Warranty Bulletin

95-09

Date: **April 1995**
Section: **16**
Subject: **Transversal Radius Rod on Tag Axle**
Application:

FIGURE 1

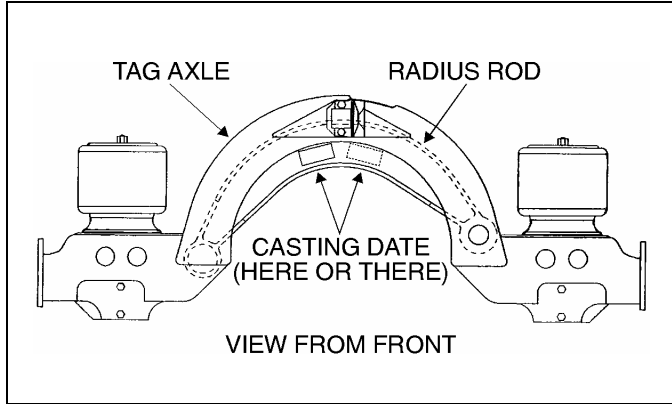
1. Under vehicle, in the rear axles section, locate tag axle transversal radius rod (Fig.1).
2. Verify casting date on the radius rod (Fig. 1 and Fig. 2), if it is 310394 or 160994, perform step B, otherwise, don't perform it.

FIGURE 3

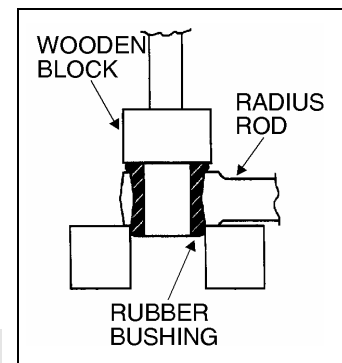
2. Safely support the new radius rod, and place bushing on top of the radius rod end.
3. Place a wooden block on top of bushing and press on it manually (Fig. 3), use a hammer if necessary. Redo step 1 to 3 for the second bushing.
4. Under vehicle, in the rear axles area, locate tag axle transversal radius rod (Fig. 1).

FIGURE 4

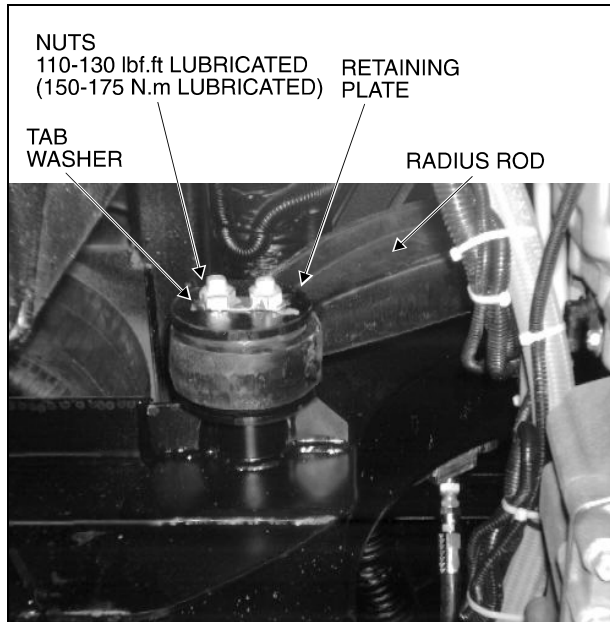
5. On left end of radius rod, flatten the tab washer which secures the two retaining nuts, then unscrew the nuts and remove retaining plate (Fig. 4).
6. On the other end of radius rod, flatten tab washer which secures the two bolts, then unscrew them. (Fig. 5).
7. Unscrew the two bolts and nuts retaining radius rod support (Fig. 5), and remove radius rod.

9. At right end, place support, fix it with bolts and nuts and tighten lightly. Place new tab washer, two bolts retaining radius rod, tighten bolts lightly.
10. At the other end, place retaining plate, new tab washer and nuts, tighten nuts lightly.
